PHAP12-00012

Historic District: Sunset HeightsLocation: 1316 Missouri

Request: Certificate of appropriateness for the construction of a two story duplex.

SITE PLAN

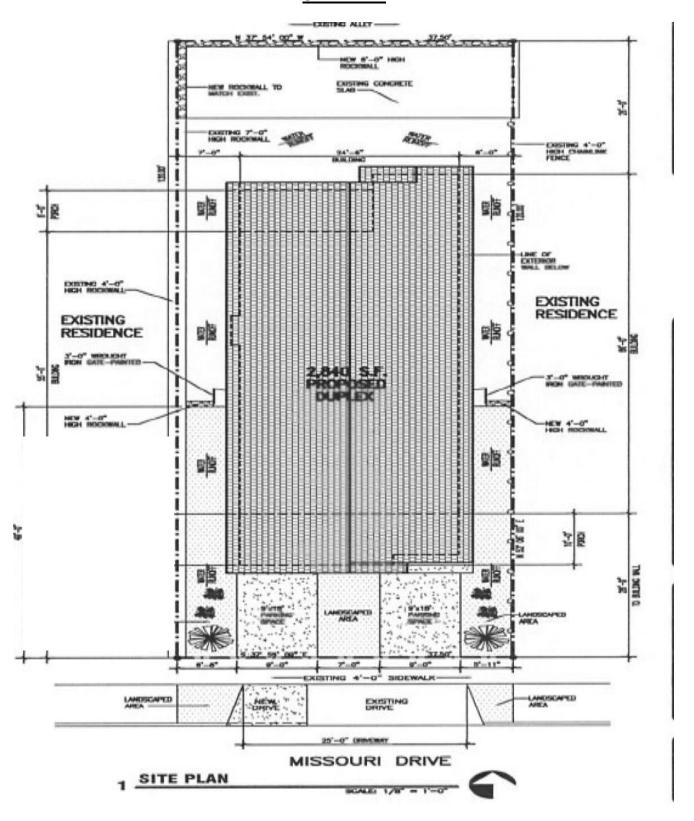
The modifications are that the parking spaces at the front of the main facade be eliminated and that the new building be constructed in line with the adjacent buildings, the eaves be extended outward up to two feet, and the window surrounds on the main façade will be replaced with sills.

We didn't see any dumpster on the site plan but with only 2 apt units, we imagine they can use trash cans instead of placing dumpsters in front of the house.

PROPOSED ELEVATIONS

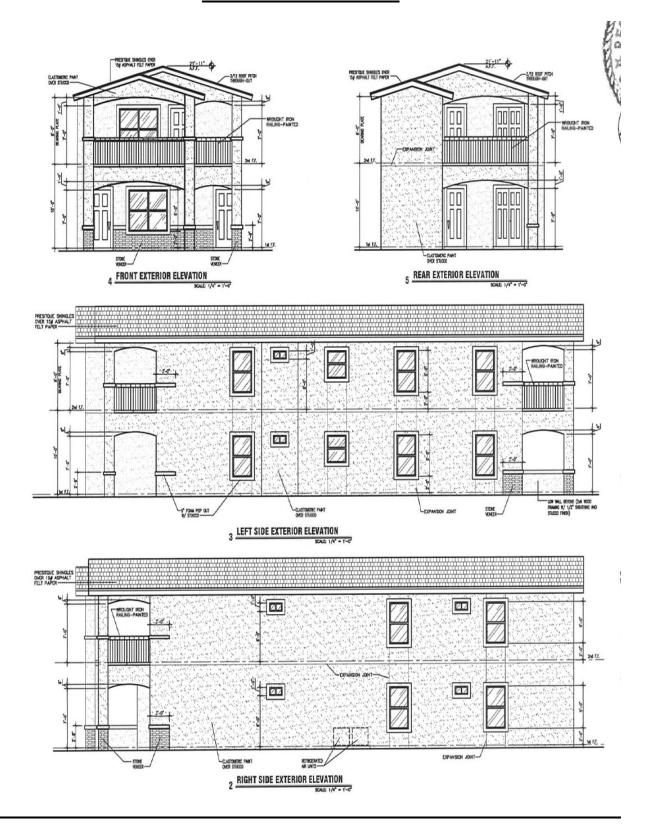
- 1. Roof pitch should be no less than 4/12 to match surrounding houses.
- 2. Arch radii on the porch opening tops should match those found on the property across the street.
- 3. First floor picture window should be completely above the stone veneer.
- 4. Need cut sheets for:
- Roof shingles color
- -Exterior color pallet color
- -Stone veneer
- -Wrought iron pattern

We noticed the plans had an architect stamp and it made us think: If the architect could properly incorporate some longer strong roofline eaves (see photo) instead of the usual anemic East-side-of-EP eaves, it'd do wonders in conforming to the neighborhood.
